Access Compliance Report Public Rights-of-Way (Pedestrian Signals)

Main Street: **MAGNOLIA_AVE** Cross Street: **PACIFIC_AVE** Location: **NW**

ADA ID: **SGAT220202094357** Signal Type: **One Push Button-APS** Overall Compliance: **No** Severity Scores: **BTN 1: 25** **BTN 2: N/A** **No BTN: N/A**

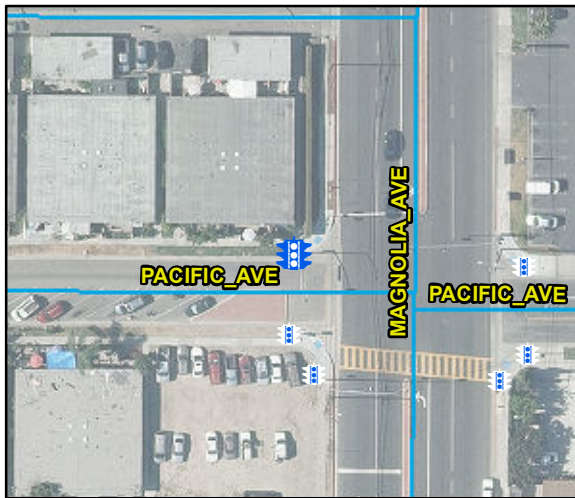
OC Std/PROW: **R404.2**

Possible Solutions: Remove and Replace Clear Space.
